APPLICATION NO.	FILING DATE	FIRST NAMED INVENTOR	ATTORNEY DOCKET NO.	CONFIRMATION NO.
10/777,019	02/11/2004	Tushar Patel	101896-234 (DEP5100CIP)	2233
	7590	EXAMINER		
	DE CENTER WEST	COMSTOCK, DAVID C		
155 SEAPORT BOULEVARD BOSTON, MA 02210-2604			ART UNIT	PAPER NUMBER
			3733	
			NOTIFICATION DATE	DELIVERY MODE
			02/20/2009	ELECTRONIC

Application No.	Applicant(s)				
	10/777,019	PATEL ET AL.				
Office Action Summary	Examiner	Art Unit				
	DAVID COMSTOCK	3733				
The MAILING DATE of this communication app Period for Reply	ears on the cover sheet with the c	orrespondence address				
A SHORTENED STATUTORY PERIOD FOR REPLY IS SET TO EXPIRE 3 MONTH(S) OR THIRTY (30) DAYS, WHICHEVER IS LONGER, FROM THE MAILING DATE OF THIS COMMUNICATION. - Extensions of time may be available under the provisions of 37 CFR 1.136(a). In no event, however, may a reply be timely filed after SIX (6) MONTHS from the mailing date of this communication. - If NO period for reply is specified above, the maximum statutory period will apply and will expire SIX (6) MONTHS from the mailing date of this communication. - Failure to reply within the set or extended period for reply will, by statute, cause the applic

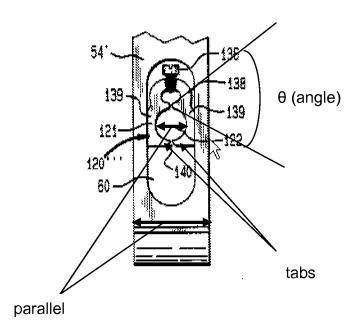
Greenberg discloses the claimed invention including elongate members, e.g. 54' and guides comprising first and second pathways (see openings in element 120"). See Fig. 27B and illustration below. A cut-out portion extends between the two openings or pathways (id.). The cutout is formed through the guide, which necessarily includes at least the sidewall between the pathways. The pathways extend parallel to a portion of a front surface of the distal portion of the elongate member (see illustration, below). The pathways are positioned at an angle with respect to one another. The guide comprises various sidewalls and the opposed lateral sidewalls comprise a C-shape. The guide includes extension portions comprising first and second tabs extending from opposed lateral sidewalls of the guide member. Each tab has a concave inner surface. The

guide has a width that is less than a distal portion of the elongate member. A distal portion of the elongate member comprises a planar portion and is positioned at an angle with respect to a back sidewall of the guide member. The device can comprise a single retractor or be coupled with a second retractor by a handle, which can be considered a cross member since it connects the two (see, e.g., Fig. 20). It is noted that the elongate member comprises a proximal handle *portion* (i.e. a portion to which the handle is connected), as claimed, as well as a cross member (i.e. the handle itself). In addition, claim 55 does not recite any particulars regarding the handle being removably connected. The device is capable of being used in the claimed manner.
